BID ADDENDUM NO. (2)

12/28/2023
South Seneca CSD
2022 Capital Improvement

The following Addendum items shall be considered a part of the contract documents prepared by HUNT ENGINEERS, ARCHITECTS, LAND SURVEYORS & LANDSCAPE ARCHITECT, DPC. Bid Document date of November 30th, 2023.

WALL SECTIONS AND DETAILS

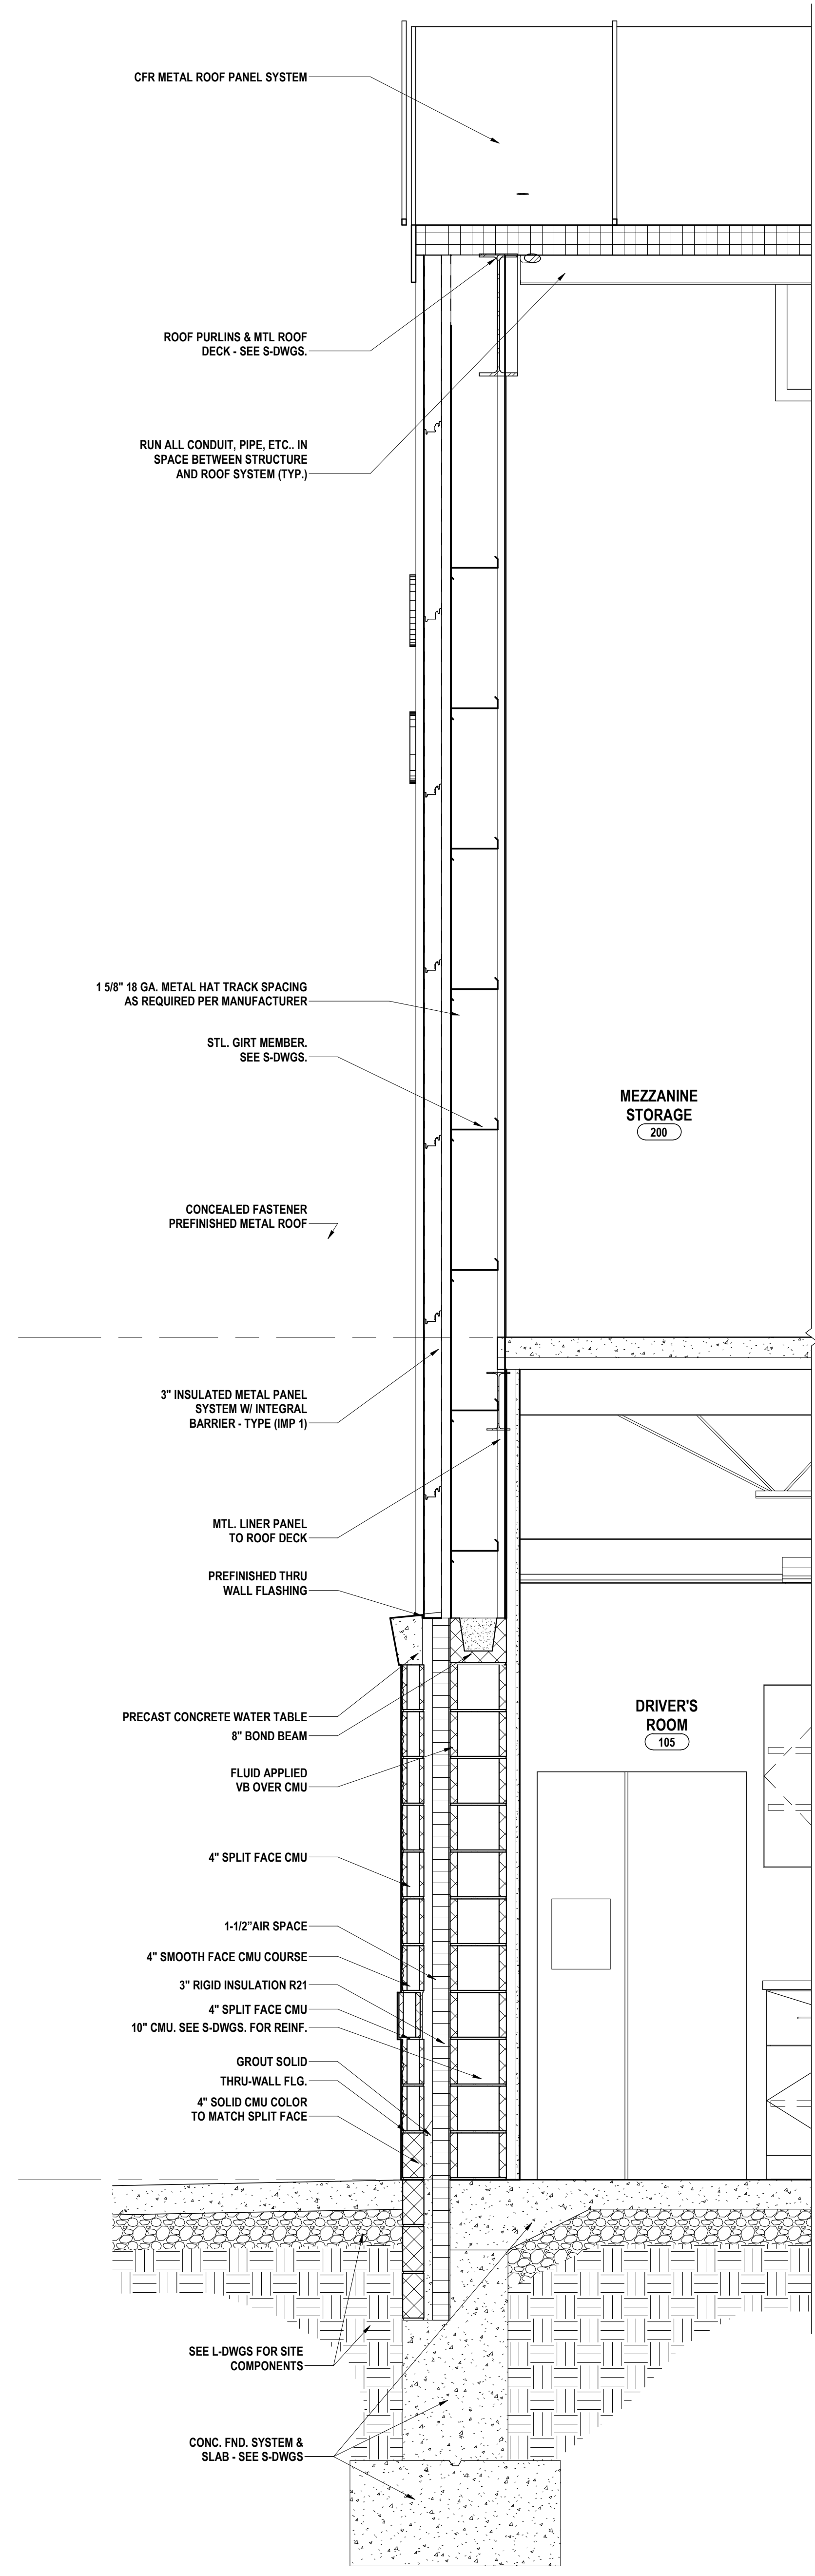
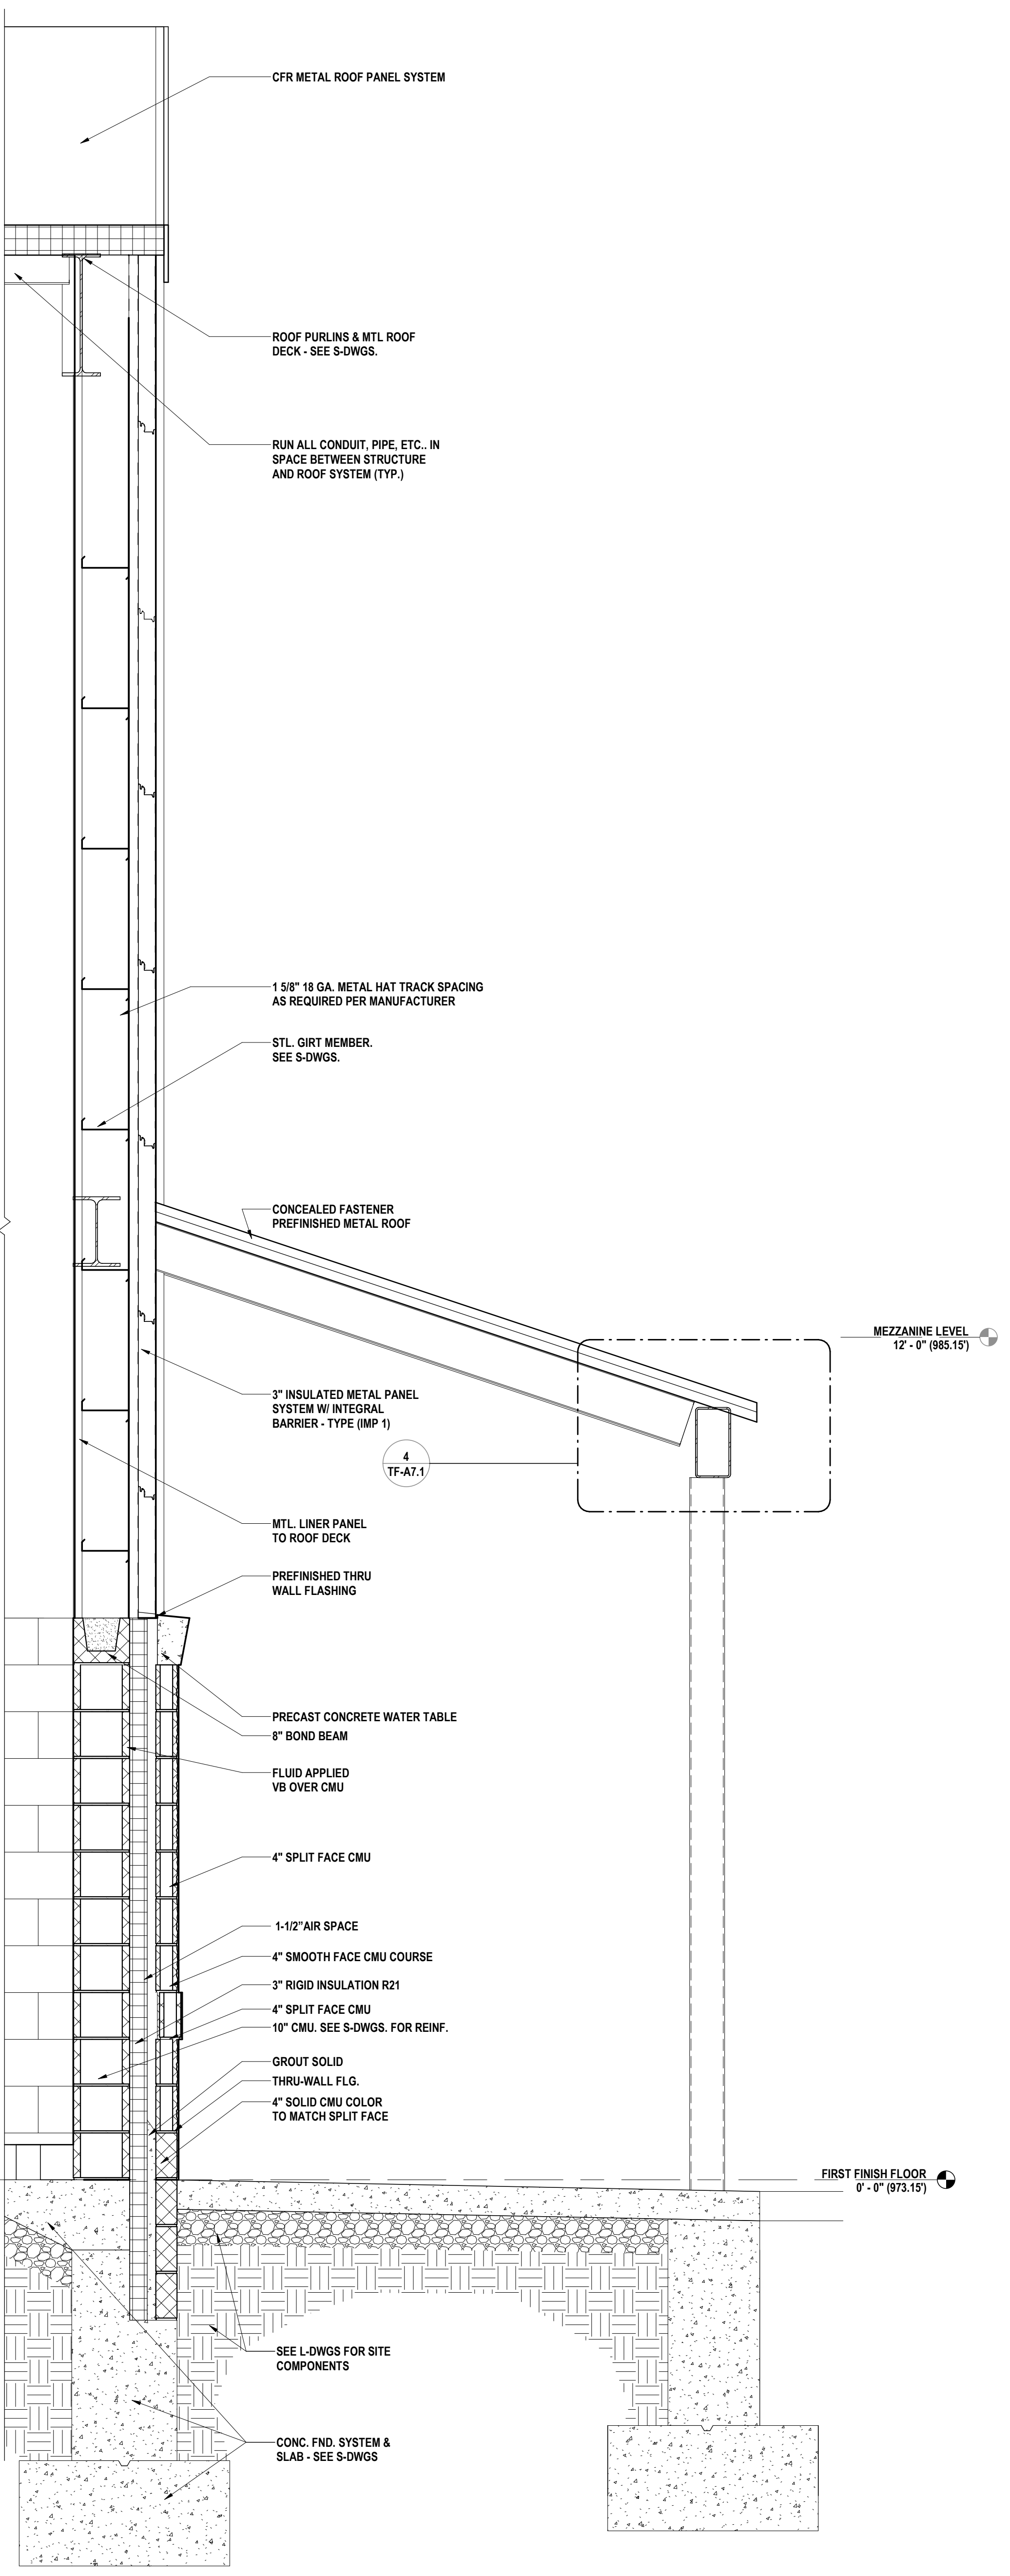
ITEM AD2-9 Refer to TF-A4.2 – WALL SECTIONS AND DETAILS

DELETE Sheet

ITEM AD2-10 Refer to TF-A4.2 – WALL SECTIONS AND DETAILS

ADD Sheet issued via this addendum.
